# Access Compliance Report

## Public Rights-of-Way

### (Curb Ramps)

Intersection ID: 50706	Main Street: GENERATIONS_ST	Cross Street: BROTHERLY_LN	Location: NW
ADA ID: 86D1955CA426	Ramp Type: Perp	Initial Pass/Fail: Fail	Overall Compliance: No
Severity Score: 25			
Codes/Mitigation Info/Possible Solution		Field Measurements/Component Compliance

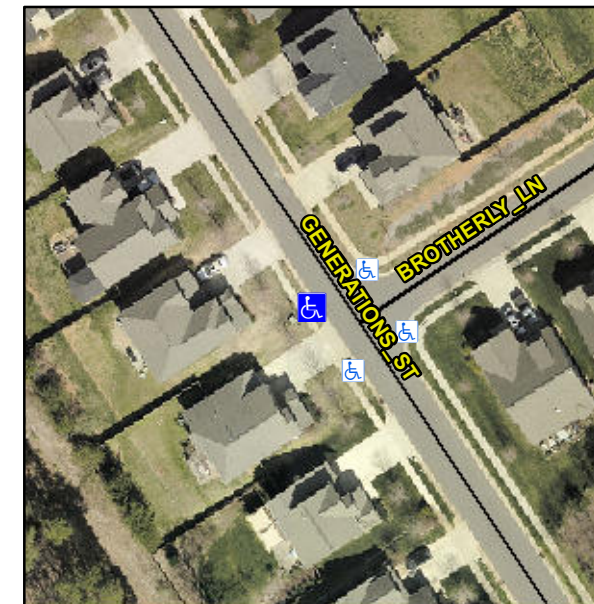
**Not Found, R304.2.2, R304.5.3**

Compliance	Description	Data	Compliance	Description	Data
N/A	Ramp Length (in)	48.5	No	Ramp Slope (%)	9.3
Yes	Ramp Width (in)	48.0	No	Ramp XSlope (%)	5.4
N/A	Flare Type LT	N/A	N/A	Flare Type RT	N/A
N/A	Flare Slope LT (%)	N/A	N/A	Flare Slope RT (%)	N/A
N/A	Flare Traversable LT?	N/A	N/A	Flare Traversable RT?	N/A
N/A	Landing Length (in)	N/A	N/A	DWS Provided?	N/A
N/A	Landing Width (in)	N/A	N/A	DWS Contrast?	N/A
N/A	Landing Slope (%)	N/A	N/A	DWS Length (in)	N/A
N/A	Landing X Slope (%)	N/A	N/A	DWS Full Width?	N/A
N/A	Landing Curb? (Y/N)	N/A	N/A	DWS Offset (in)	N/A
N/A	Shared Landing?	N/A			
N/A	Gutter Ponding?	N/A	N/A	Gutter Slope (%)	N/A
N/A	Gutter Lip Ht (in)	N/A	N/A	Gutter X Slope (%)	N/A
N/A	Painted X Walk1?	No	N/A	Painted X Walk2?	N/A
	X Walk 1 Direction	To NE		X Walk 2 Direction	N/A
N/A	X Walk 1 Width (in)	N/A	N/A	X Walk 2 Width (in)	N/A
	X Walk 1 Slope (%)	2.5		X Walk 2 Slope (%)	N/A
	X Walk 1 X Slope (%)	6.0		X Walk 2 X Slope (%)	N/A

**Remove & Replace Entire Ramp.**
